Well Name: PURE GOLD MDP1 29-17 FED COM	Well Location: T23S / R31E / SEC 29 / SESE / 32.2698692 / -103.794464	County or Parish/State: EDDY / NM
Well Number: 175H	Type of Well: OIL WELL	Allottee or Tribe Name:
Lease Number: NMNM0281482A	Unit or CA Name:	Unit or CA Number:
US Well Number: 3001545780	Well Status: Drilling Well	Operator: OXY USA INCORPORATED

Subsequent Report

Sundry ID: 2652389

Actual Procedure: OXY USA Inc. received BLM verbal approval to plugback and sidetrack the subject well. Pease see the attached details on the current well status, plan forward to sidetrack and wellbore diagram for reference.

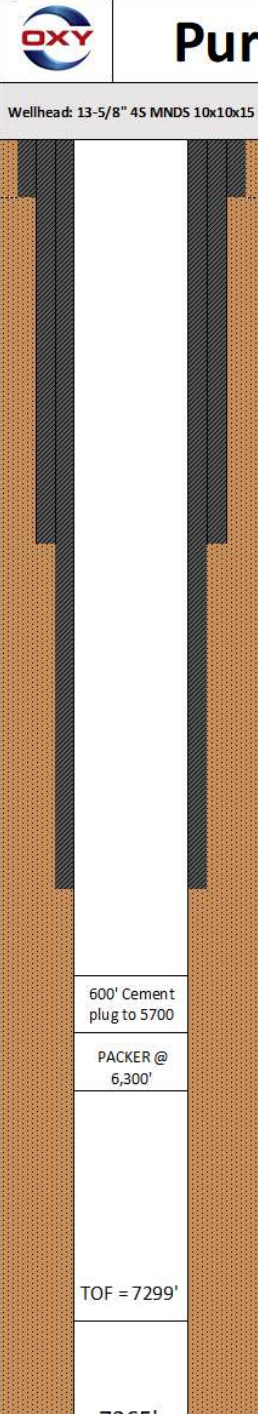
As discussed, H&P 479 left tools in the hole while drilling 8-3/4" intermediate section on the Pure Gold MPD1 29_17 Fed Com 175H. We will have to sidetrack the original wellbore around the fish to complete the section as per plan.

- 9-5/8" casing set at 4292'

- Original hole drilled to 7365'
- Top of fish at 7299'
- TAM open hole packer set at 6300'

- Pump 600' cement plug on top of packer from 6300'-5700'
- Sidetrack wellbore in the 5700' – 5800' range
- Continue drilling 8-3/4" intermediate hole as per plan

Please see attached wellbore schematic that summarizes current state and plan forward. Please let me know if you need anything else from me.

You have verbal to move forward as planned. Please submit a subsequent sundry within 5 days of the verbal approval. Please plan to bring cement to surface on the next casing. If cement does reach surface please contact the appropriate BLM office.
